**From:** Ferrante, Fernando *mlr*  
**Sent:** Tuesday, August 17, 2010 7:00 PM  
**To:** James, Lois  
**Subject:** IN on NSAC/60  
**Attachments:** NSAC60 Discussion.docx

## DISCUSSION ON THE HISTORICAL USE OF DAM FAILURE RATES IN PROBABILISTIC RISK ASSESSMENT OF OPERATING NUCLEAR POWER PLANTS IN THE US

## NSAC/60 External Flooding Analyses

Figure 2. Comparison of results for the cumulative distribution of the PMP frequency

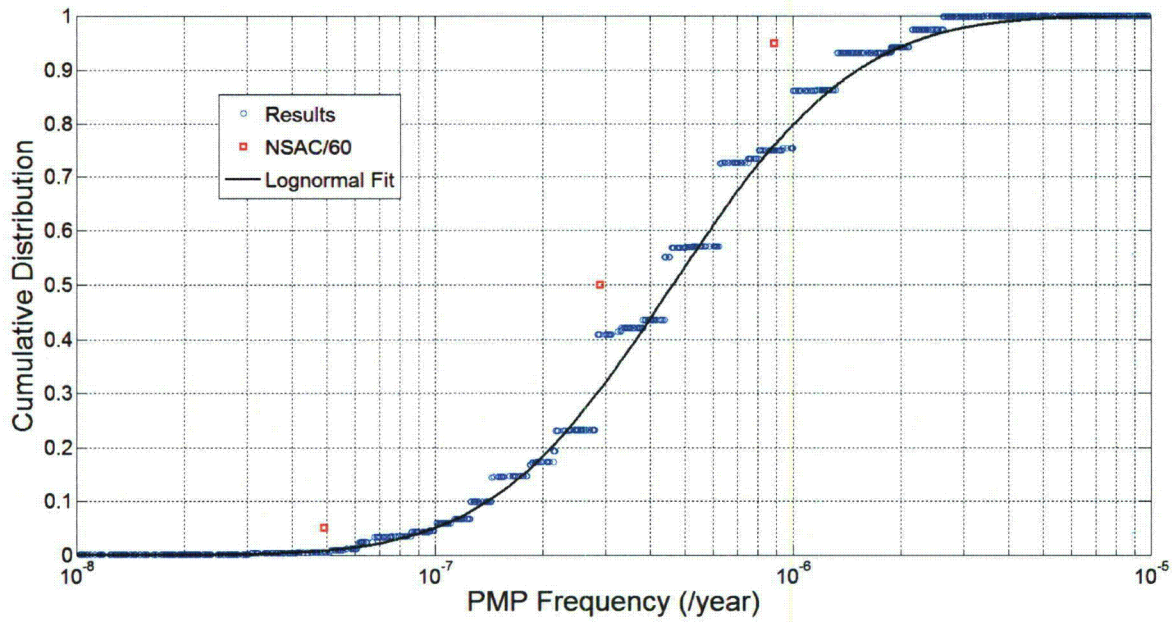
A comparison of the results is shown in Figure 2. The results from NSAC/60 (Page 9-117) appear to under predict the replicated values where, for example, the 95<sup>th</sup> percentile is obtained as 1.6E-6/year versus the NSAC/60 result of 8.9E-7/year. Since the original analysis is not available, it is difficult to assess whether this difference is due to numerical calculations, data input, or another cause. Ultimately, the real challenge in the analysis presented is the justification for extrapolating limited data to such extreme low values. As good practice dictates, the higher and more refined the quality of the data, the more supportable the justification for extrapolation becomes. As far as extreme precipitation phenomena are concerned, the issue of frequency estimation has been debated by several US federal agencies and entities involved with hydrologic applications. A good summary of the state-of-the-art is provided in the 1999 joint report by Utah State University and the US Bureau of Reclamation titled "A Framework For Characterizing Extreme Floods for Dam Safety Risk Assessment," where the limits of credible extrapolation for annual exceedance probabilities are set at 1/100,000 with the inclusion of optimal data inputs (i.e., best combination of data), beyond what is presented in NSAC/60.

Figure 3. Comparison of dam failure rate estimates for dams built between 1900 and 1981

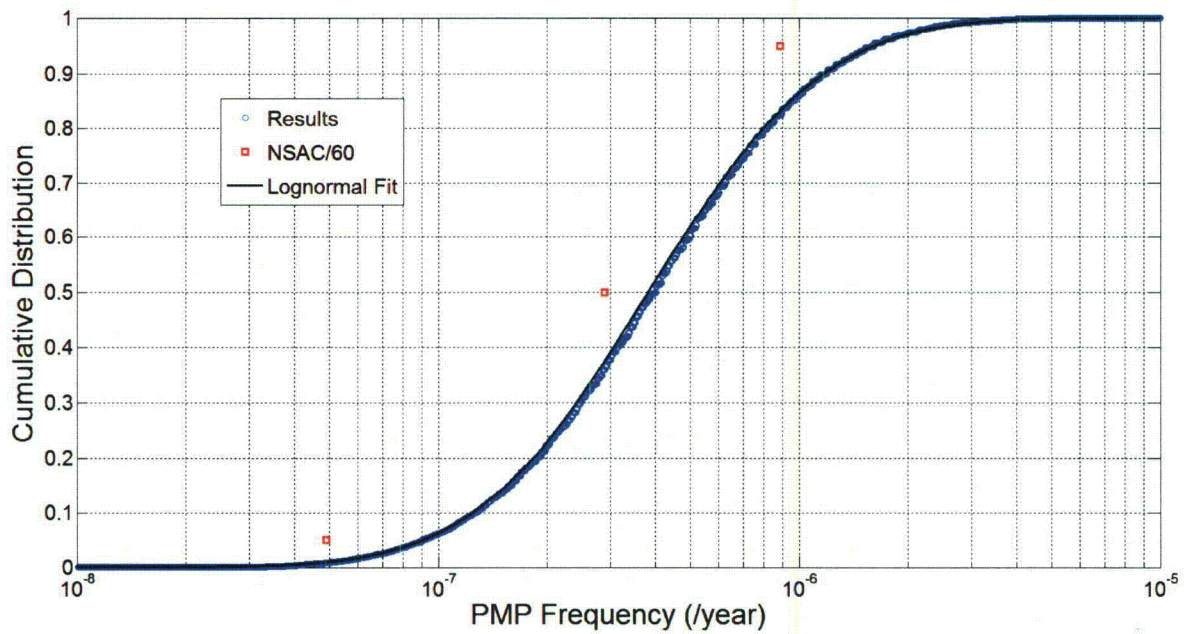
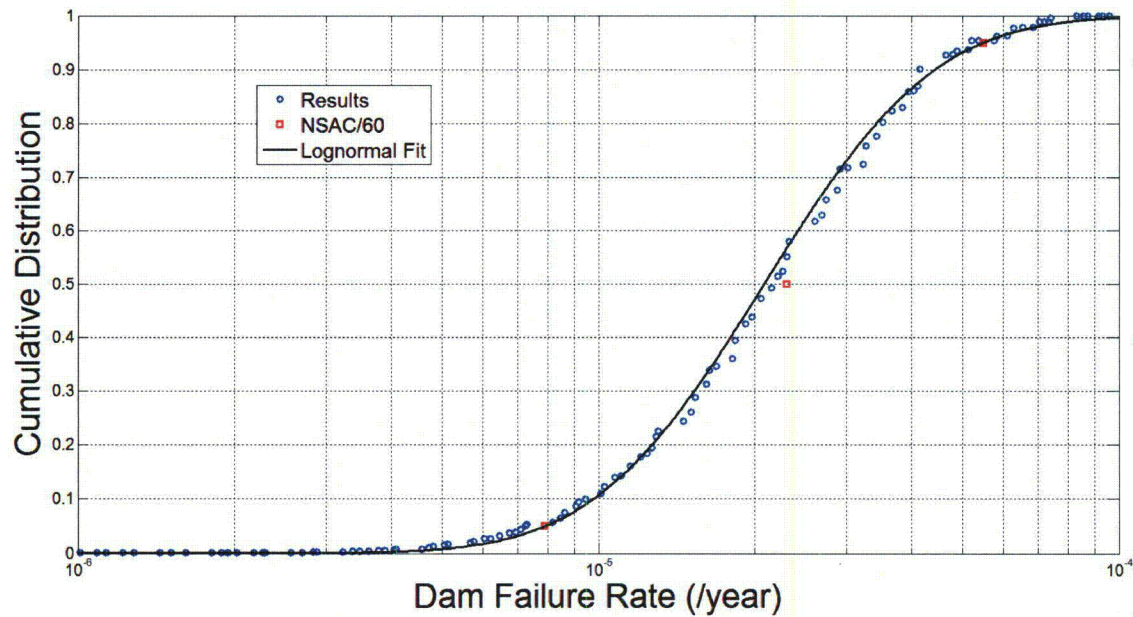
The results for dams built after 1900 (see Figure 3) show that the analysis with the original grid compares well with the NSAC/60 results. However, using a more refined grid indicates that the Bayesian updating used is sensitive to the grid arrangement. The 95<sup>th</sup> percentile with the more refined grid is 4.3E-5/year, compared to the NSAC/60 value of 5.5E-5/year. Overall, the results for the dam failure rate and the PMP frequency are close enough for the purposes of validating the result and the noted differences are not significantly different, despite the discrepancies observed. Additionally, the different periods considered in the study were compared to the results presented in NSAC/60 (see Figure 4), where at each overlapping period interval only those failures applicable are considered (i.e., 5 failures between 1900 and 1981, 2 failures between 1940 and 1981, and 1 failure between 1960 and 1981), with a recalculated number of dam-years is derived for each period.
